**CITY OF OREGON  
OREGON, OHIO  
WATER TREATMENT PLANT – CONCRETE REPLACEMENT PROJECT**

**Addendum No. 2  
May 8, 2024**

To: Prospective Bidders  
From: **ARCADIS U.S., Inc.**  
**One Seagate, Suite 700**  
**Toledo, Ohio 43604**  
Owner: **City of Oregon**  
**Department of Public Service**  
**5330 Seaman Road**  
**Oregon, Ohio 43616**  
Subject: **Water Treatment Plant – Concrete Replacement Project**

DRAWING NO.:  
S01-03

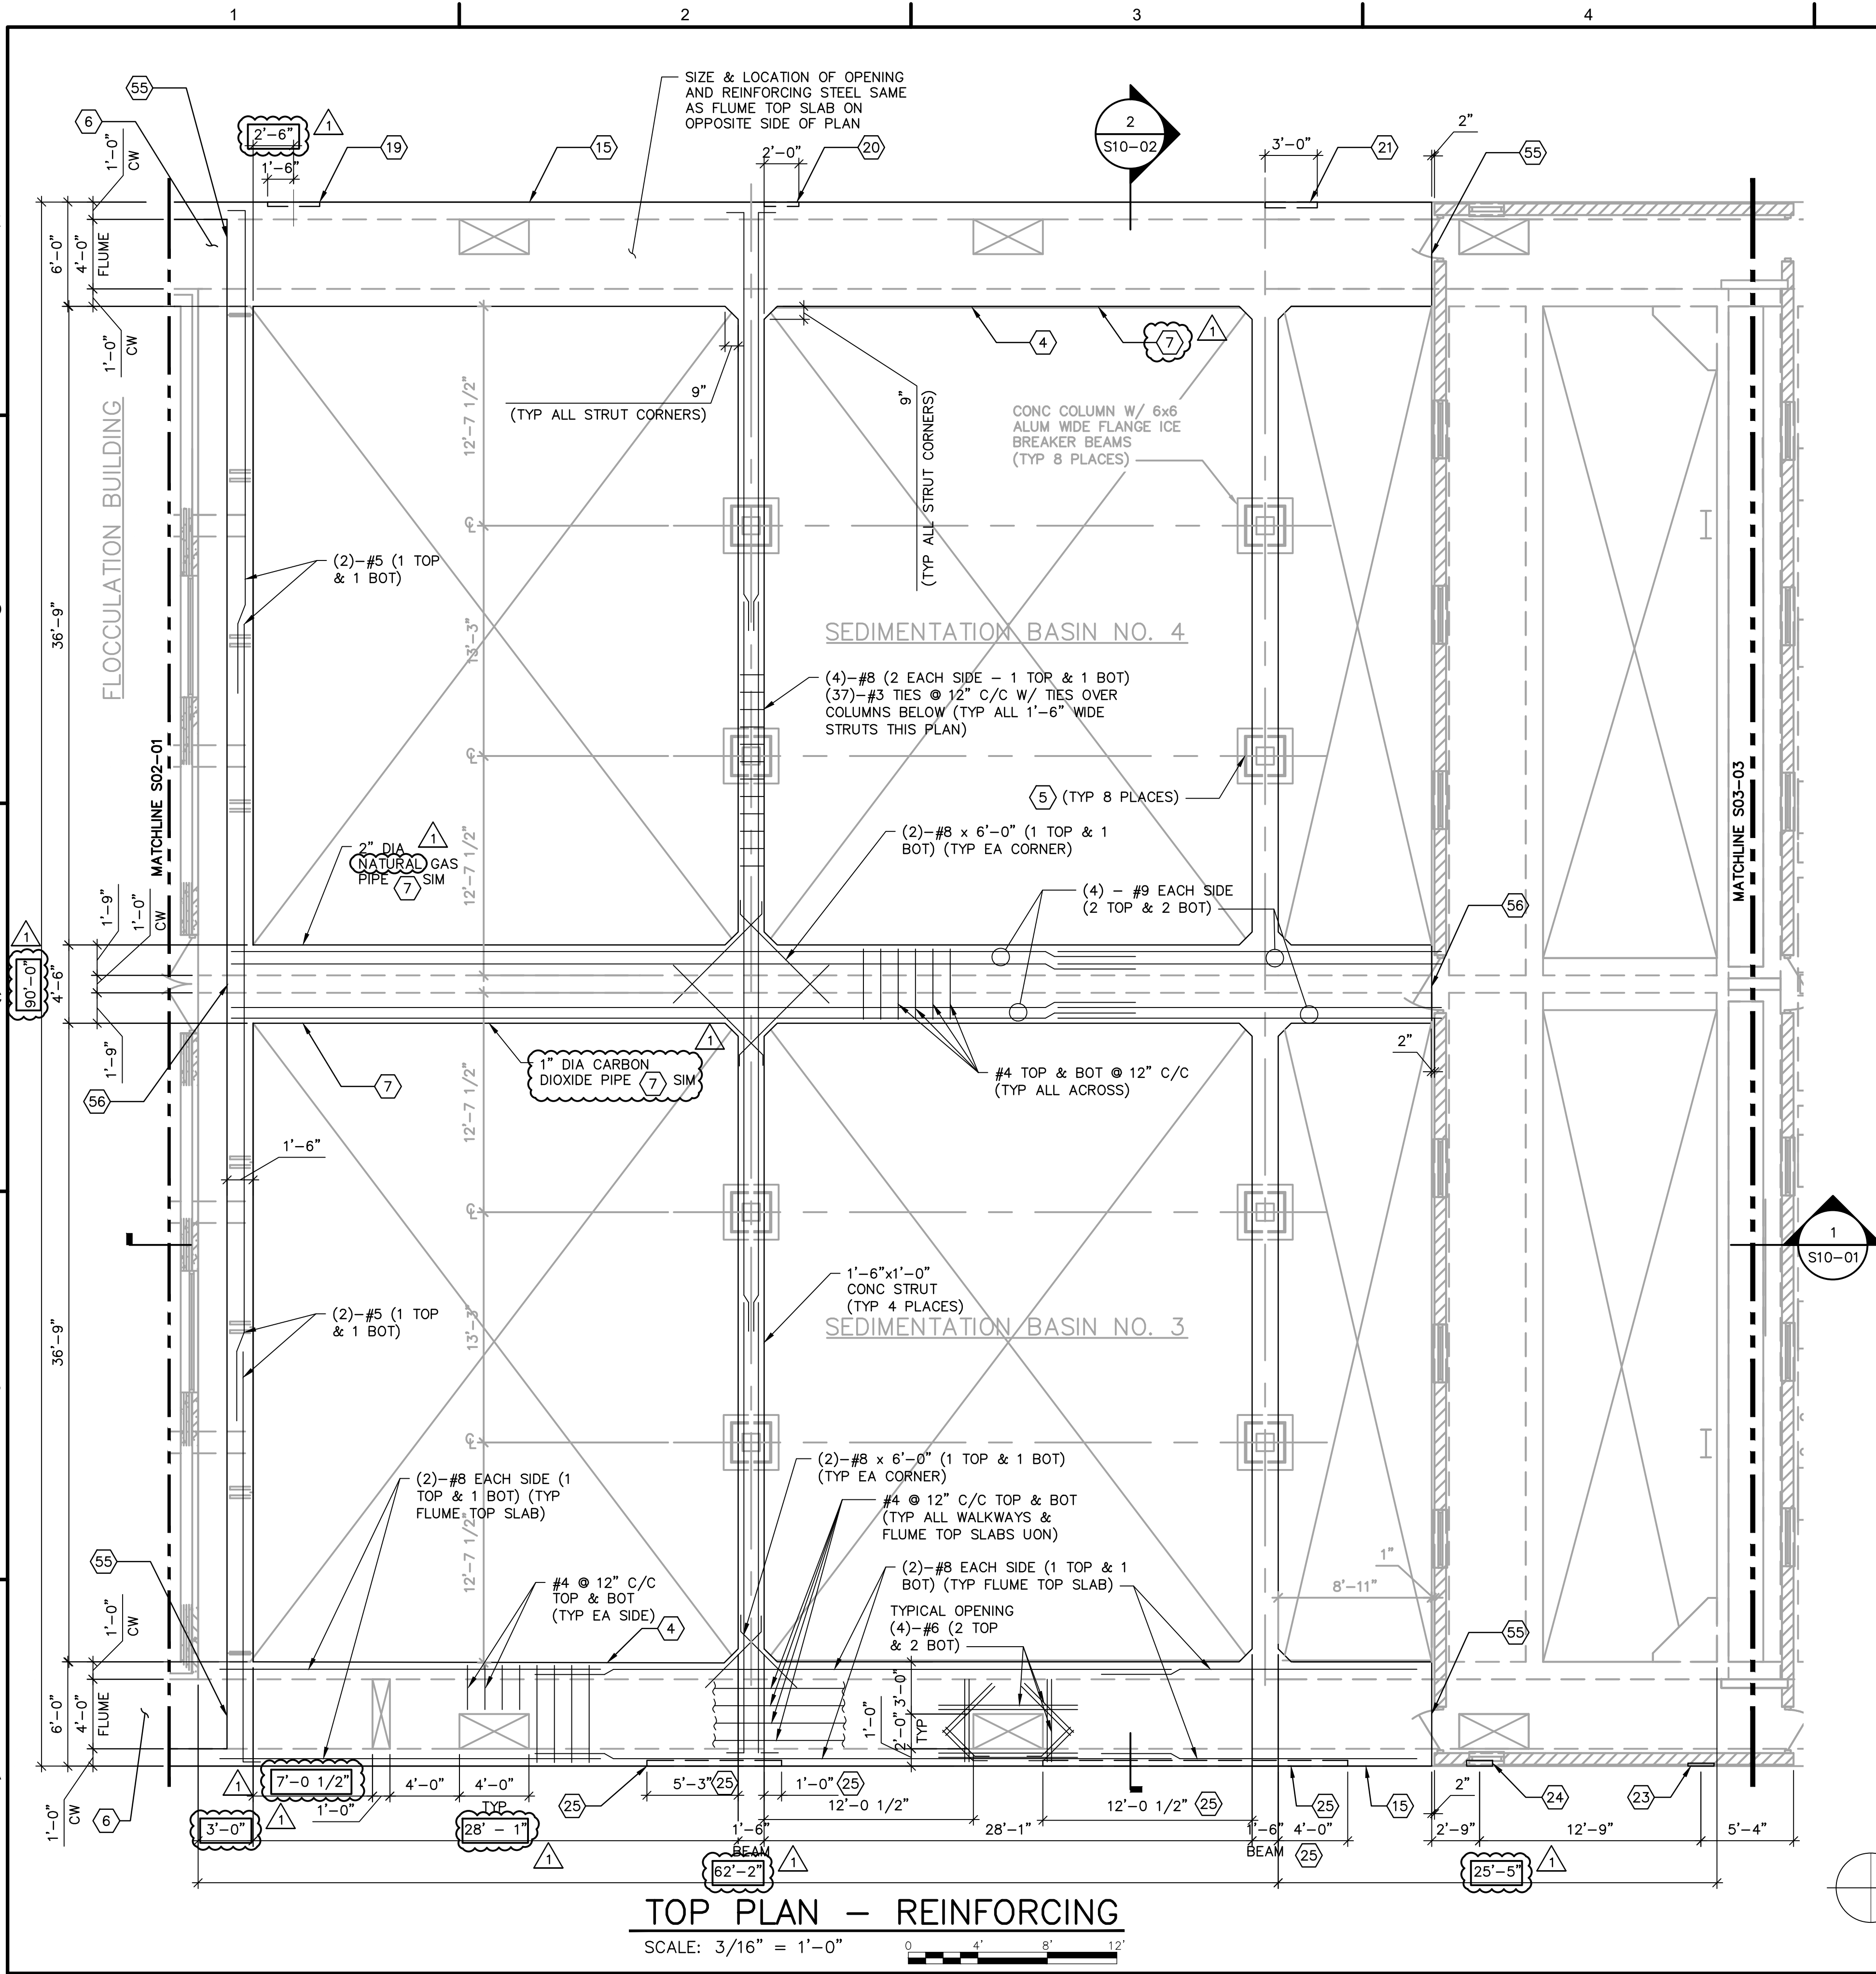
- 1.14 Drawing S01-03, SEDIMENTATION BASINS (SOUTH) – TOP PLAN - REINFORCING - Delete this sheet in its entirety and substitute revised Drawing S01-03, included with this Addendum No. 2.

5. The scale for drawing S01-03 is listed as 3/16" = 1'-0". All dimensions appear to scale correctly aside from the 25'-5", 12'- 1/2", and 87'-7" dimensions shown on the East side of the Sedimentation Basin. The 25'-5" dimension scales to 25'-10", the 12'- 1/2" dimension scales to 11'-10 1/2", and the 87'-7" dimension scales to 88'-0".

a. Can you please advise what these dimensions should be?

*Response: The specific dimensions referenced by the contractor are correct but not drawn to scale. This drawing has been revised and re-issued in Addendum No. 2 to provide clarity to this issue.*

25'-5" - DIMENSIONS WITH BOXES AROUND THEM IN PLAN ARE CORRECT BUT NOT DRAWN TO SCALE. THESE SAME DIMENSIONS WITH BOXES ALSO APPLY TO SHEETS S01-04 AND D01-02.

S03-01

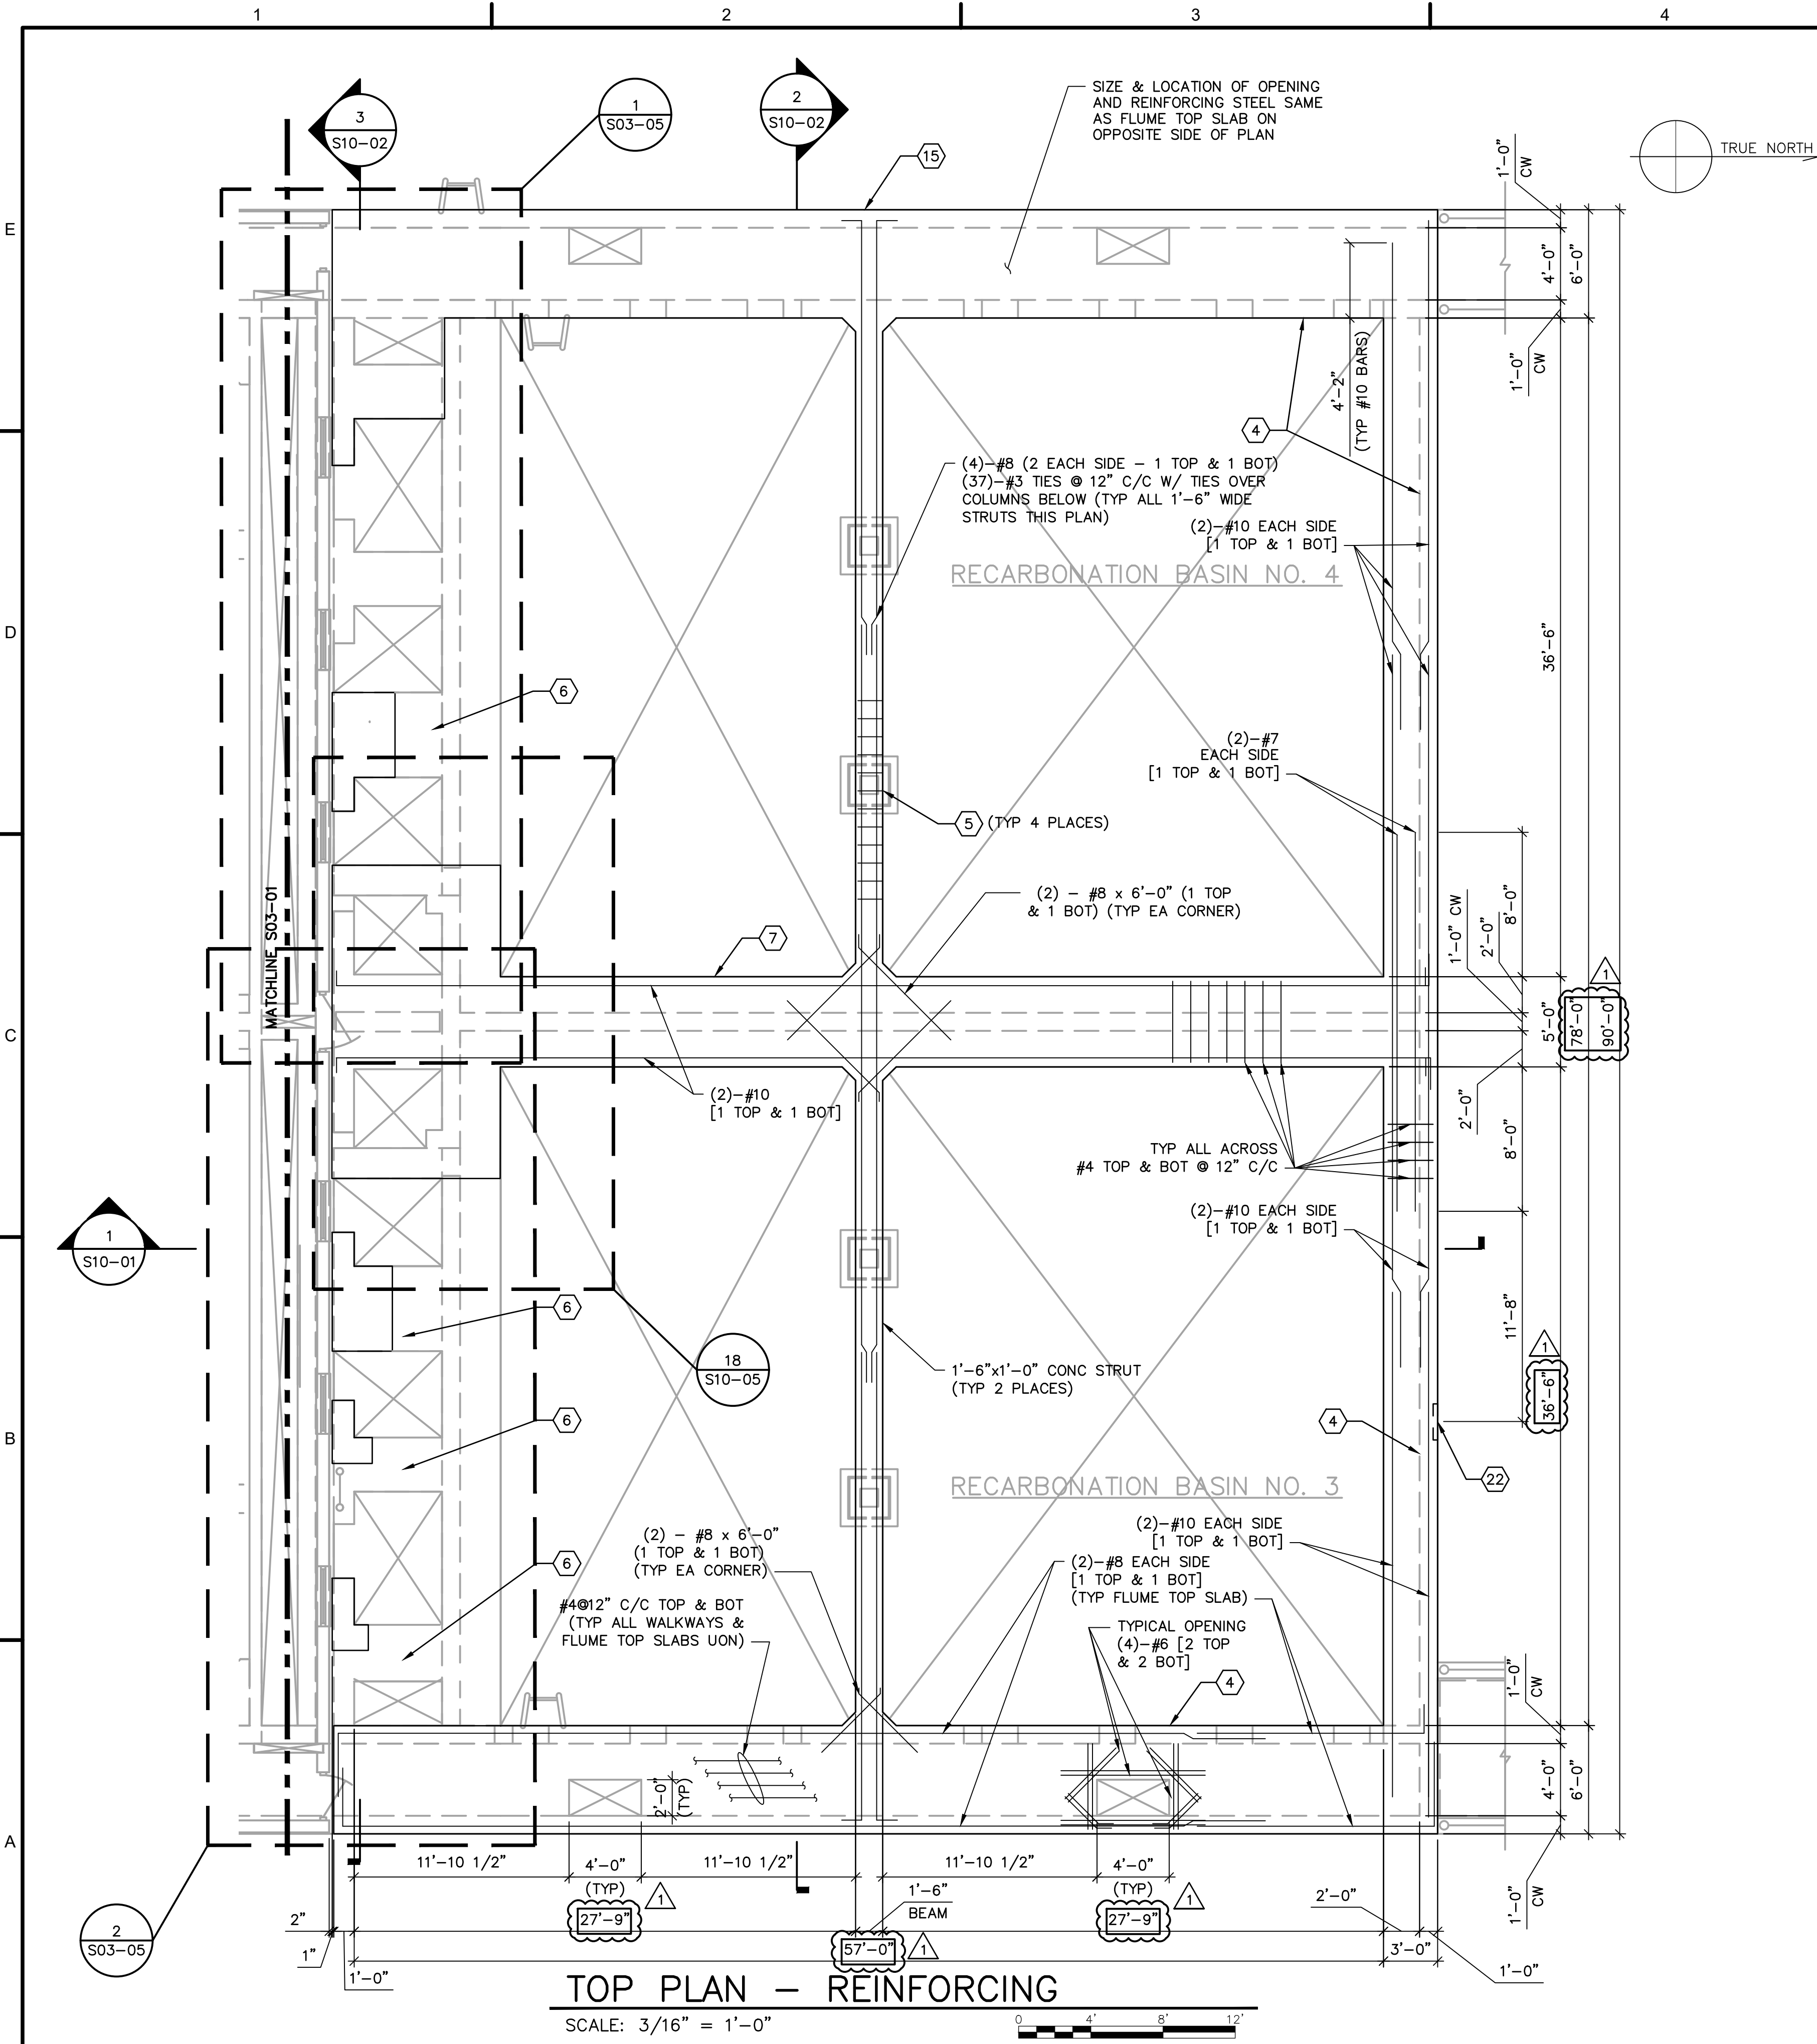
- 1.05 Drawing D03-01, SEDIMENTATION BASINS (NORTH) – TOP PLAN - In the TOP PLAN, add the following text “1” DIA CARBON DIOXIDE PIPE (KEY NOTE 7) SIM” to the east edge of the 3’-0” wide center walkway (running north-south in plan) similar to the text and location shown on revised Drawing S03-01 (included with this Addendum No. 2).

- 1.06 Drawing D03-01, SEDIMENTATION BASINS (NORTH) – TOP PLAN - In the TOP PLAN, add the following text “NATURAL” in between the words “DIA” and “GAS” for the text pointing to the west edge of the 3’-0” wide center walkway (running north-south in plan) similar to the text and location shown on revised Drawing S03-01 (included with this Addendum No. 2).

- 1.07 Drawing D03-01, SEDIMENTATION BASINS (NORTH) – TOP PLAN - In the TOP PLAN, add “KEY NOTE 7” and point to the east face of the 6’-0” wide western flume top slab (running north-south in plan) similar to the key note and location shown on revised Drawing S03-01 (included with this Addendum No. 2).

- 1.17 Drawing S03-01, SEDIMENTATION BASINS (NORTH) – TOP PLAN - REINFORCING - Delete this sheet in its entirety and substitute revised Drawing S03-01, included with this Addendum No. 2.

6. The scale for drawing S03-01 is listed as 3/16" = 1'-0". There are (11) annotated dimensions that do not scale correctly. See attached mark-up showing dimensions that do NOT scale correctly.

a. Can you please advise what these dimensions should be?

*Response: Some of the specific dimensions referenced by the contractor are correct but not drawn to scale and some of the dimensions referenced are to scale. This drawing has been revised and re-issued in Addendum No. 2 to provide clarity to this issue.*

3'-0" - DIMENSIONS WITH BOXES AROUND THEM IN PLAN ARE CORRECT BUT NOT DRAWN TO SCALE. THESE SAME DIMENSIONS WITH BOXES ALSO APPLY TO SHEETS S03-02 AND D03-01.
